IMPORTANT SAFETY UPDATE

INFORMATION BULLETIN NO. 85

SUBJ: ROCK DEFLECTOR GUARD FOR CANOPY

ILLUSTRATION 1

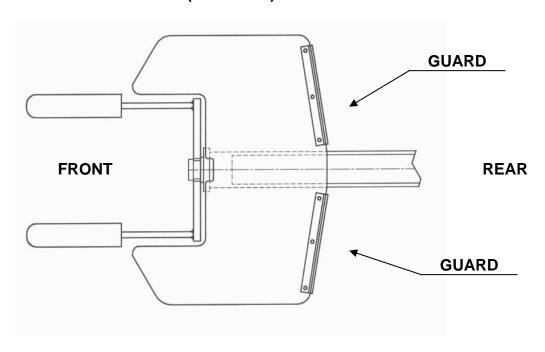
J. H. Fletcher & Co. now has a guard available for the canopy on specific DR roof drills. Two guards are mounted along the outby edge of the driller's canopy, one on each side of the TRS/canopy support arm (see illustration no. 1). The guards reduce the potential for loose roof rock to slide off the outby edge of the canopy near where the ATRS/position control station is located. The deflection guard preserves the coverage area of the existing canopy. While small rocks should not create a risk of serious injury or death, this design modification is a safety enhancement that should be added to each machine identified in this bulletin. These guards, when welded or bolted on the rear of the canopy, and used in conjunction with proper roof and rib training procedures, can reduce the possibility of smaller rocks falling on the operator.

PART NUMBER: 366506 (represents 1 guard)

ORDER <u>2</u> GUARDS PER MACHINE
